**Agenda Title:** DISCUSSION REGARDING WASTEWATER TREATMENT PLANT INFLUENT METERING SYSTEM EVALUATION

**Subject: Parshall Flume Design Memorandum**

SUBJECT: Review of City of Willits Wastewater Treatment Plant Influent Flow Meter  
B&R File No. 3478.00

PROJECT  
LOCATION  
GRAVITY INLET SEWER  
PLAN AND PROFILE

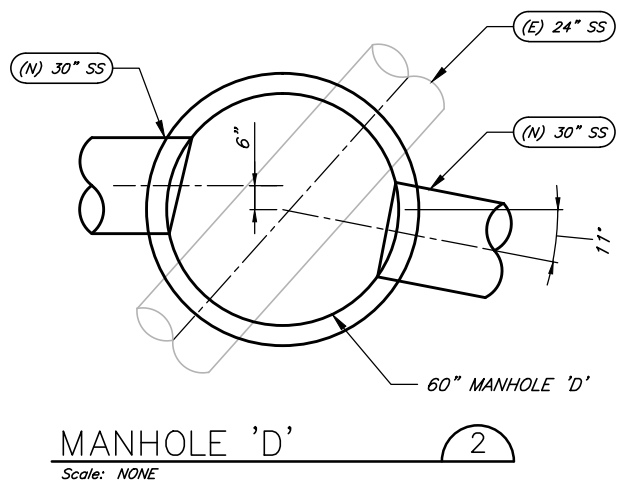
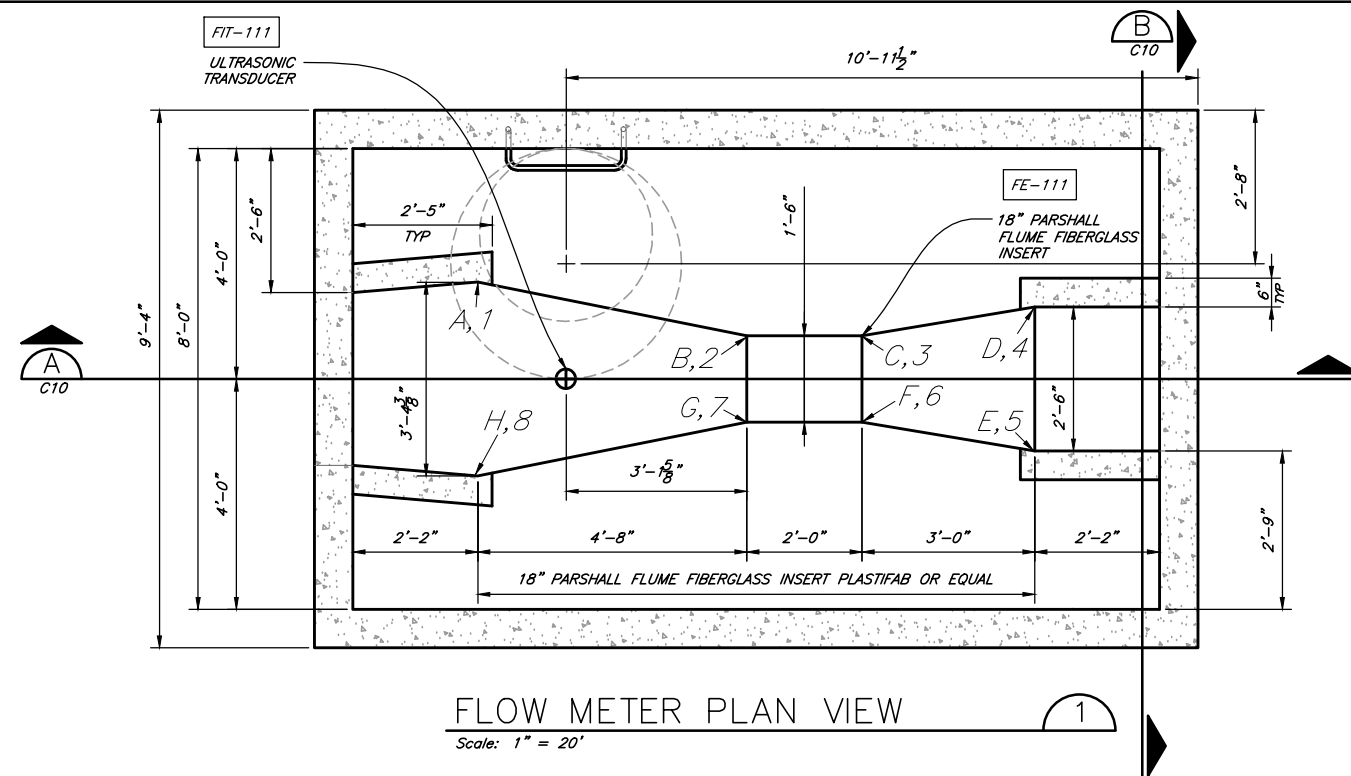
However, during the field survey by the City Engineer and staff, a construction issue was identified immediately downstream of the Parshall flume that also affects the accuracy of the influent metering system. The survey revealed that the 30” between the two manholes immediately downstream of the Parshall flume was installed at an adverse slope of 1.36% and the bottom of the pipe is below the bottom of the most downstream manhole. The pipe is also offset horizontally, creating a 3 inch lip both at the bottom of the pipe and a lip of approximately the same dimension on the south side of the pipe at the manhole. A plan and profile drawing that illustrates the situation in detail is included herewith and entitled, *Gravity Inlet Sewer Plan and Profile*.

It was recently discovered that one of the pipes downstream of the flume (between manholes C and D) was installed with an adverse grade. SHN created a model of the as-built condition to evaluate the extent of backwater effects and whether there could be an effect on the flow measurements at the flume. SHN used AutoCAD Storm and Sanitary Analysis 2012 modeling software. This software uses Manning's Equation to calculate the flow rate in conduits and open channels, and solves the complete St. Venant equations to model backwater effects through a drainage network.

CLIENT  
PROJECT  
LOCATION  
INFLUENT FLOWMETER

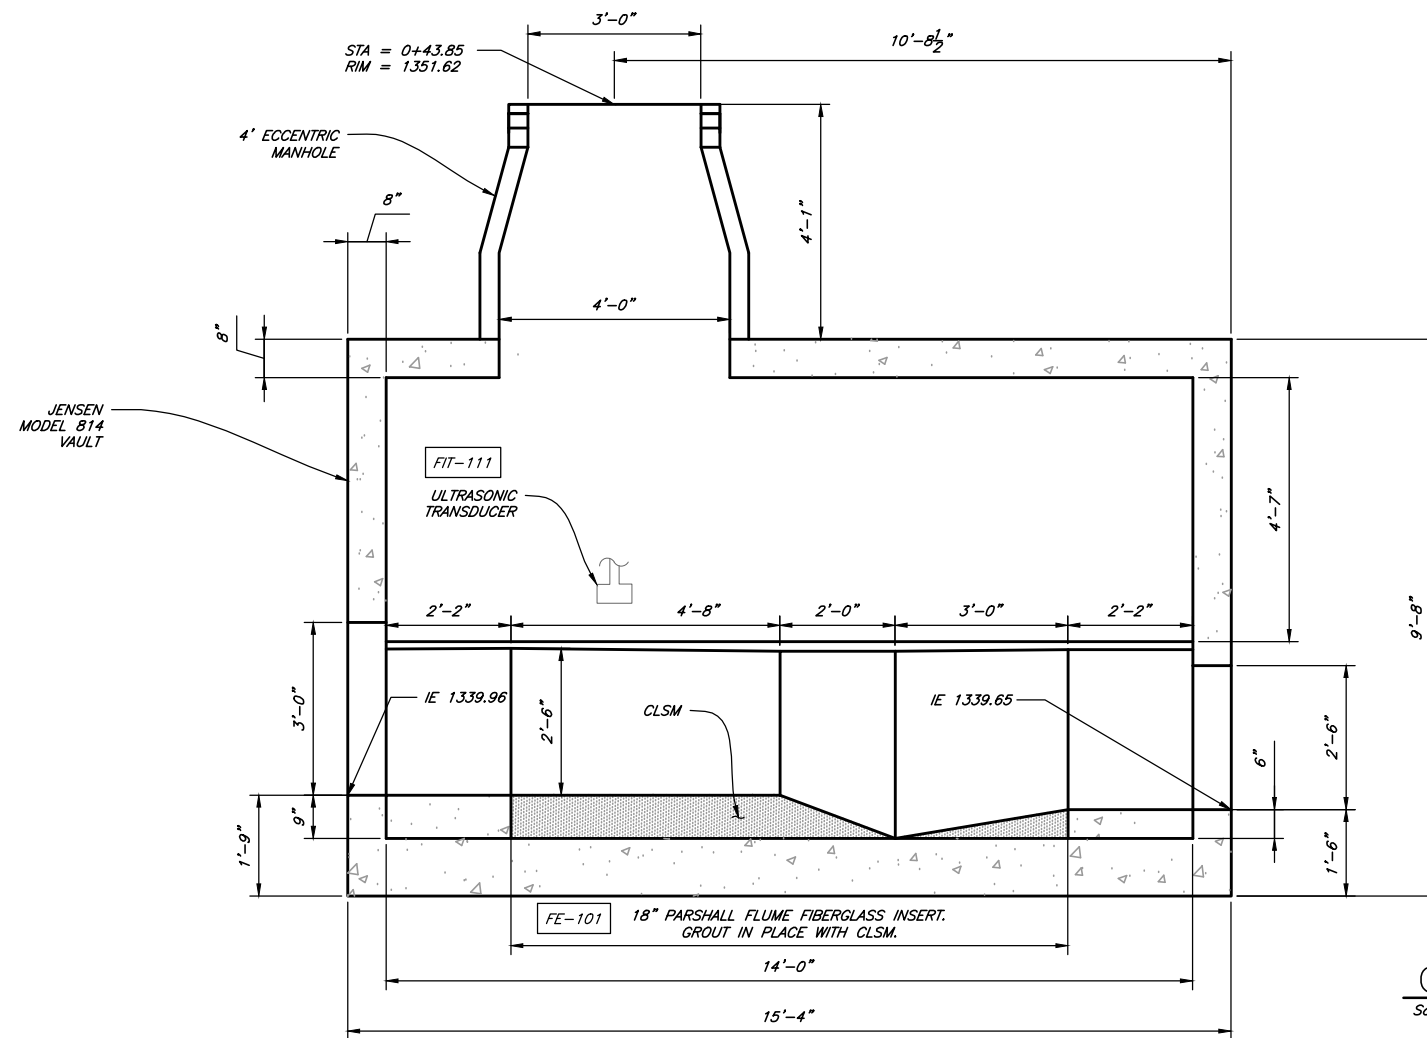
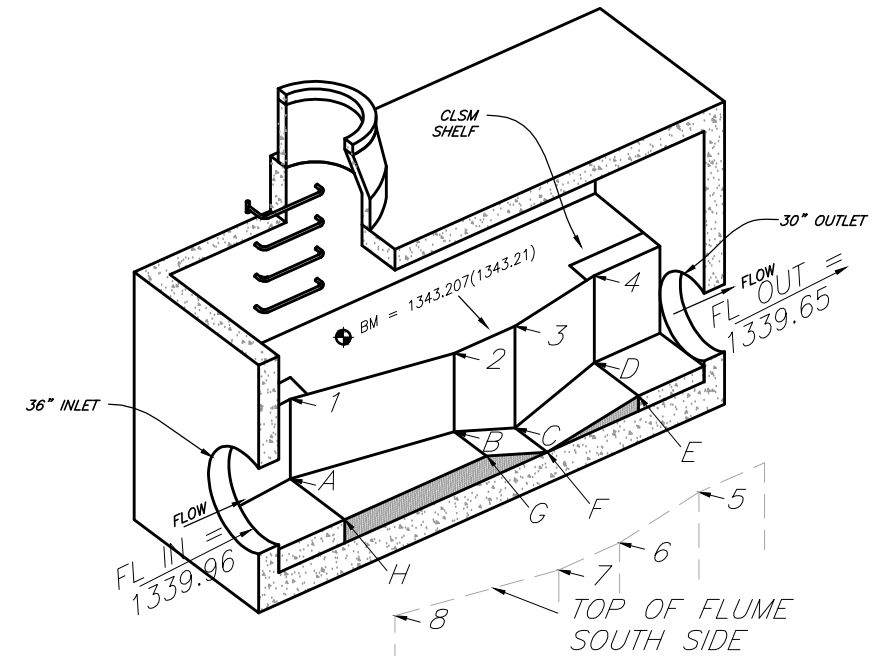
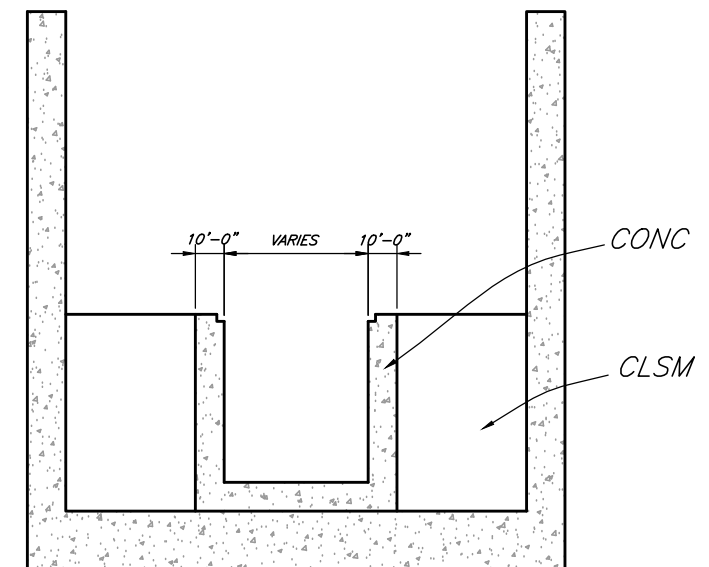
The primary issue with the construction of the Parshall flume as presented in the Brelje & Race report was that the flume was constructed at a 1% longitudinal slope and that was affecting the level of flows within the flume and, thus, skewing the resulting flow calculations. Another issue raised in the report is the fact that there are triangular voids in the concrete walls immediately upstream of the Parshall flume that cause eddies or interrupted flow that also affects the accuracy of the meter. The existence of the triangular voids is not disputed and should be corrected if the Parshall flume remains as part of the influent metering system. In order to confirm or deny the construction issue, I asked the City Engineer and staff to perform a field survey of the flume. We found a longitudinal slope of 0.88% and determined through discussions with MCC that this slope would not affect the accuracy of the influent meter.

1.18 MGD As Built Condition

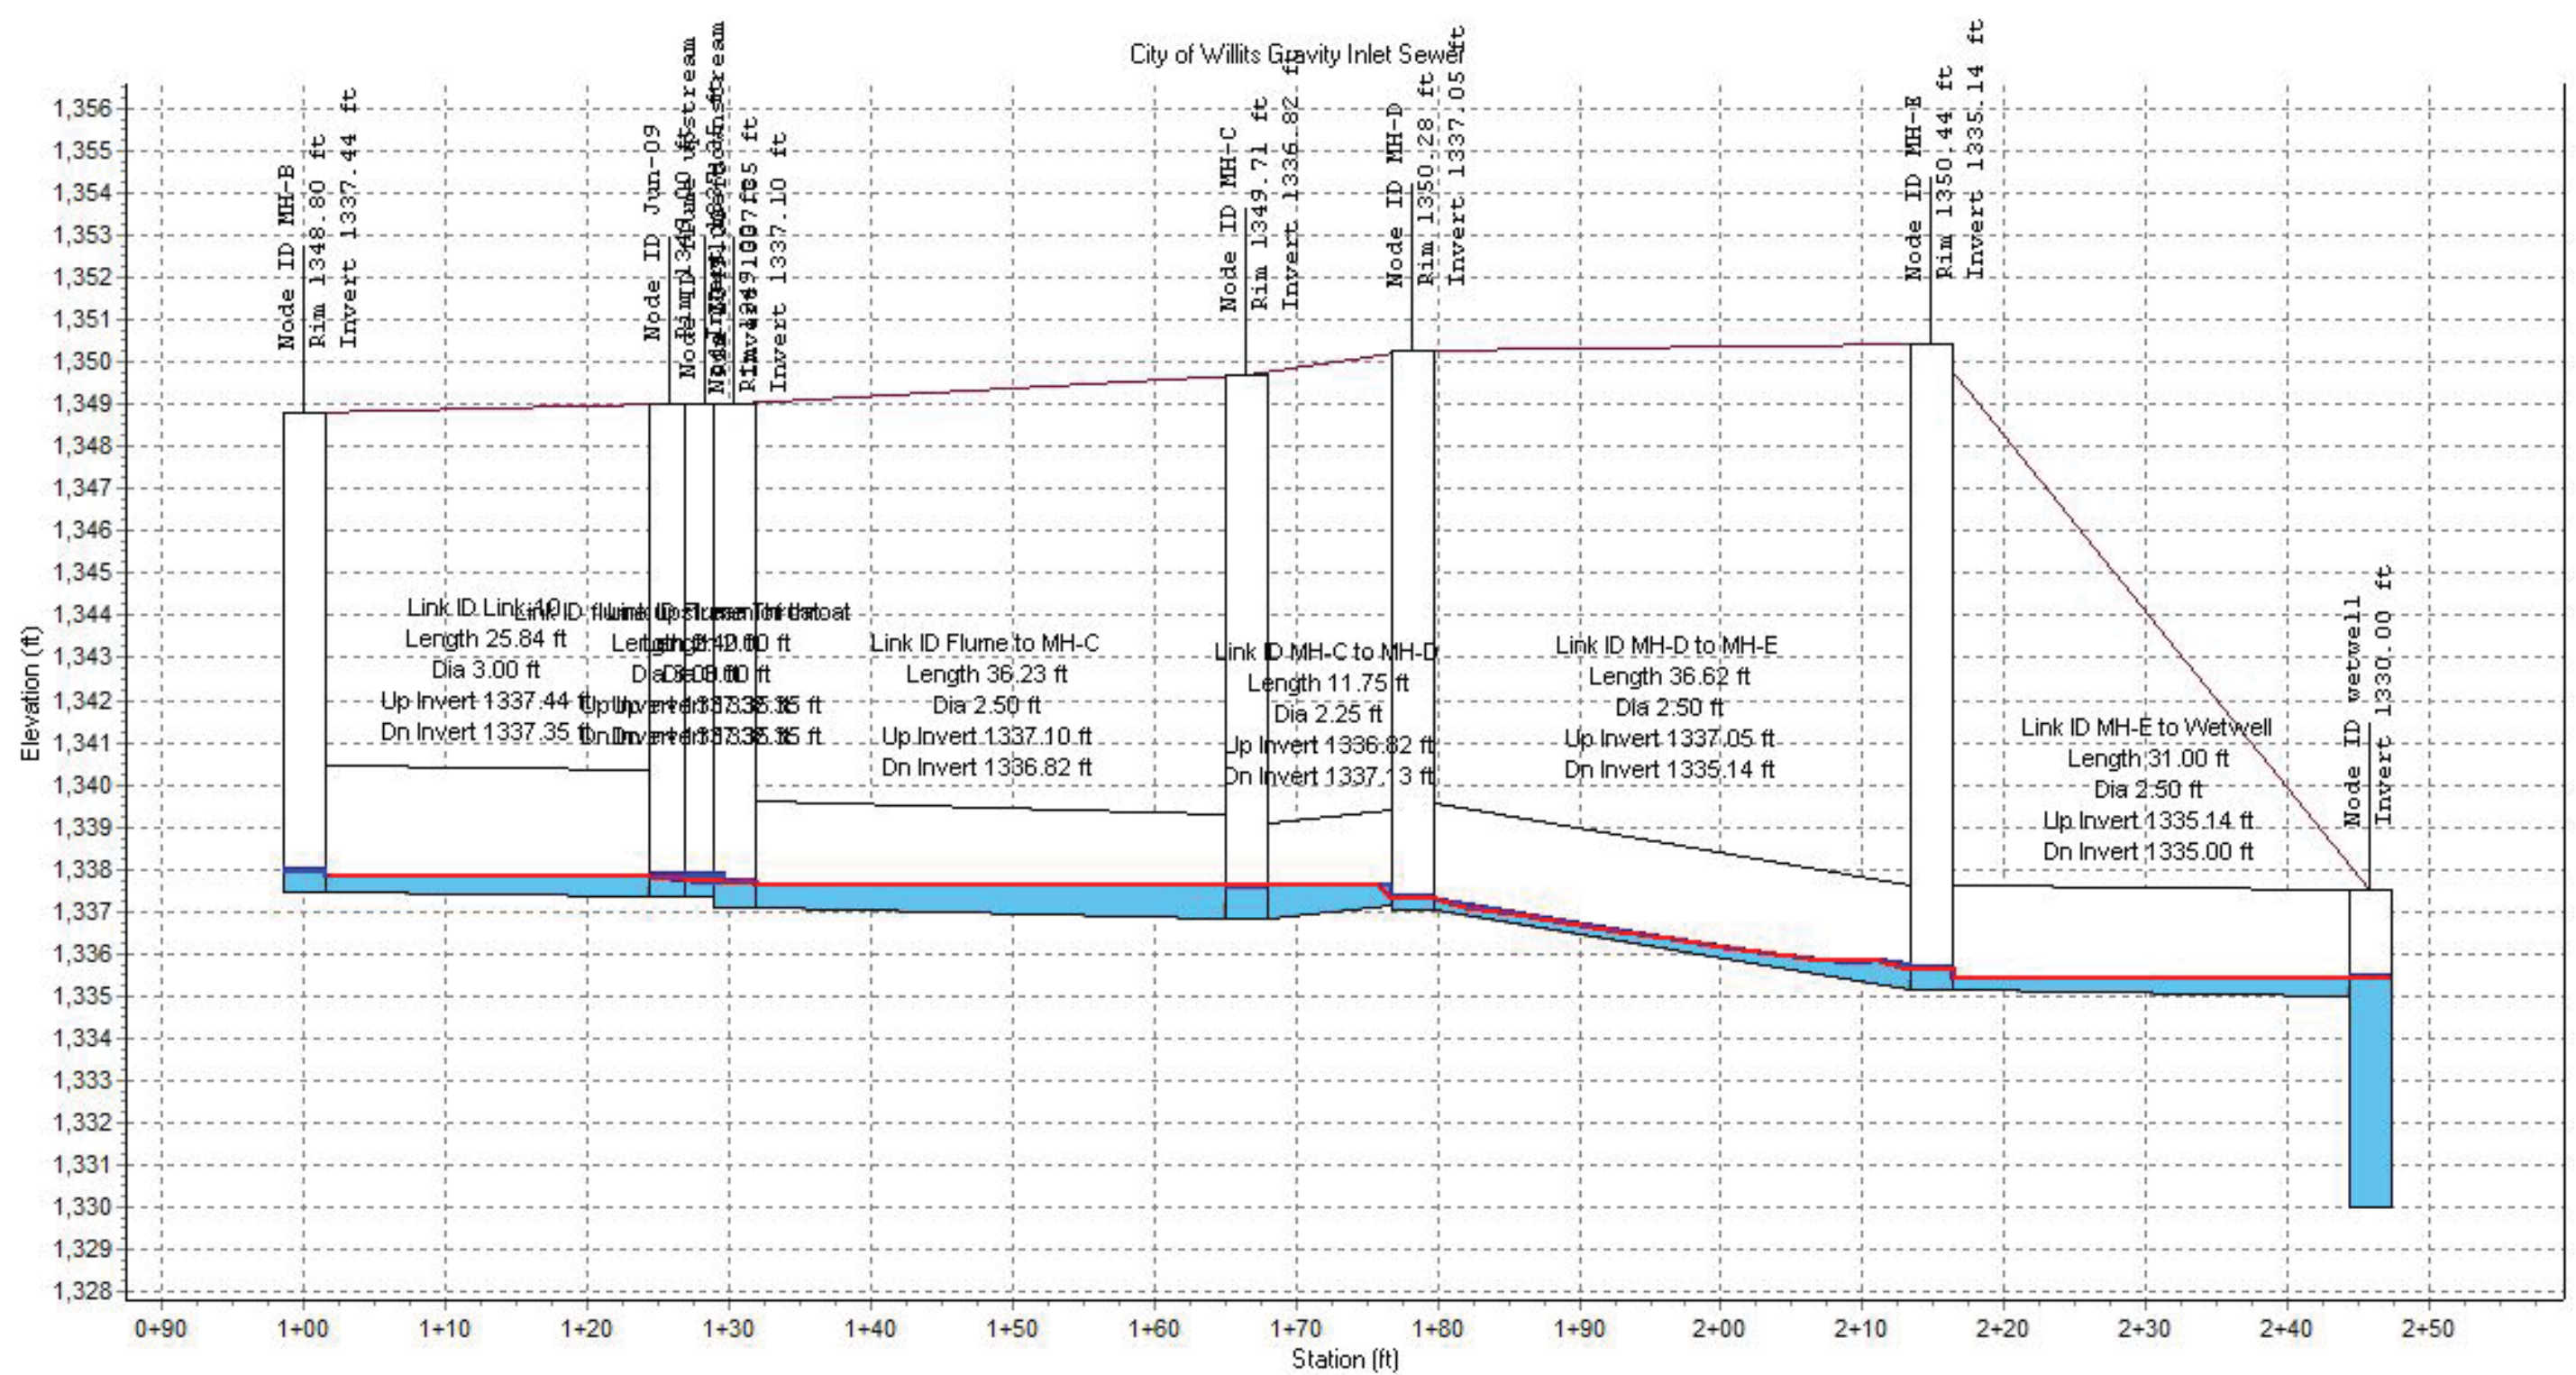
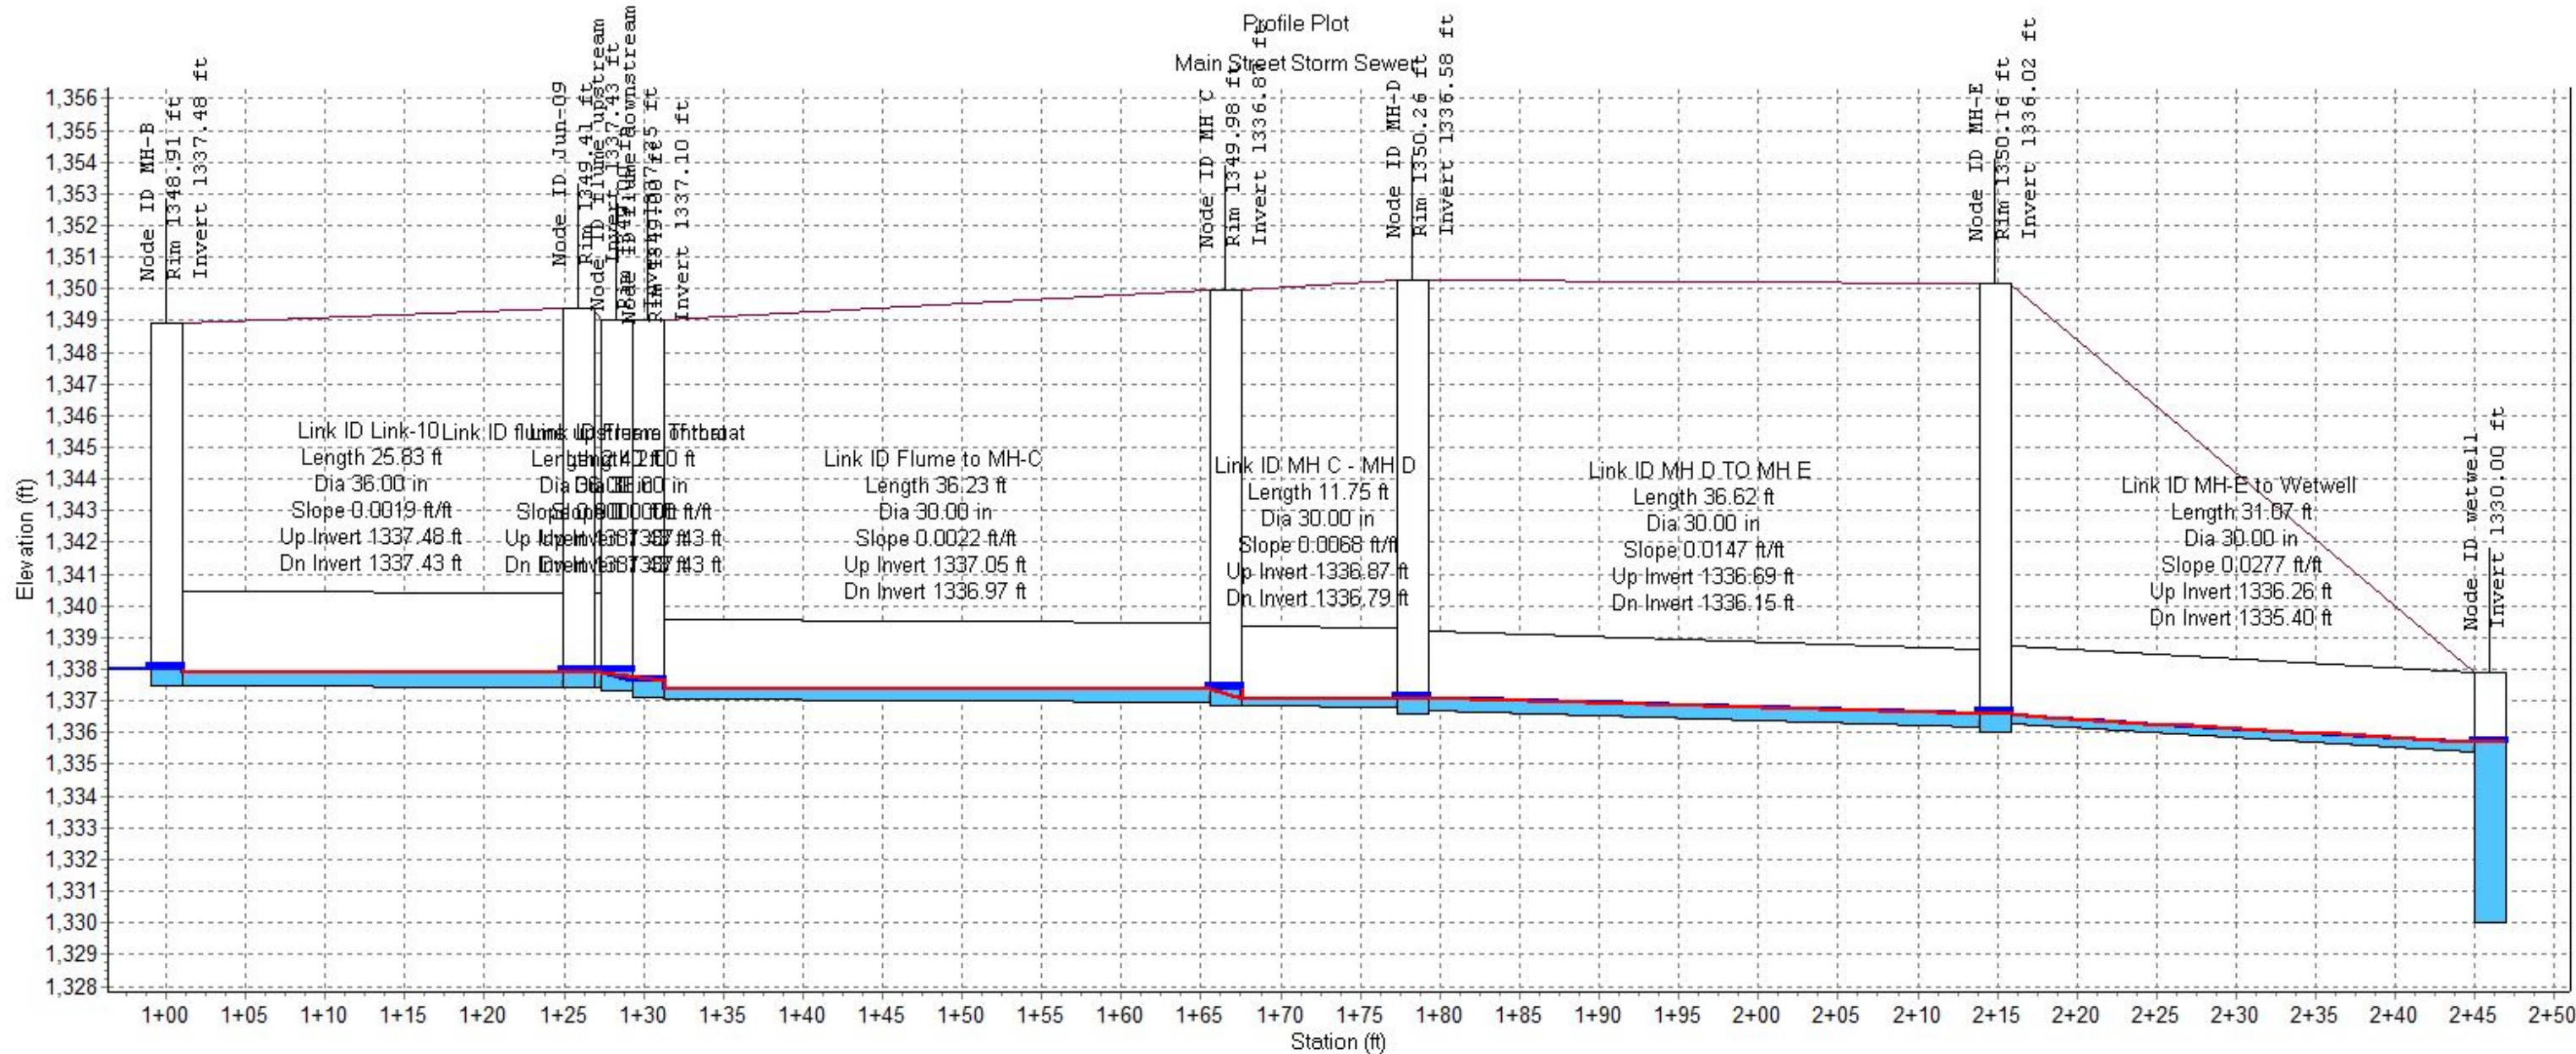
The overall model results (see attached hydraulic profiles) show that there are effects at the flume due to backwater under all three flow conditions for the as-built condition. Based on the published data, the backwater effect would result in a reading of 1.21 MGD vs. 1.18 MGD (2.5% increase), then 6.15 MGD vs. 5 MGD (23% increase), and finally 12.23 MGD vs. 10 MGD (22% increase). The model also indicates that at the as-designed condition, there would be some backwater effect at the 5-MGD and 10-MGD flow depths.

Based on discussions with a flume manufacturer, there are two ways to mitigate for the backwater effects on the flow measurement. The first is to raise the floor of the flume so that the bottom of the flume is above any backwater effects from downstream. The second is to install ultrasonic level readers at two locations along the flume. The level readings would then be fed to a programmable logic controller (PLC), which would use the correct theoretical equation, based on the presence or absence of backwater conditions, to calculate the correct flows to within the normal tolerance of a
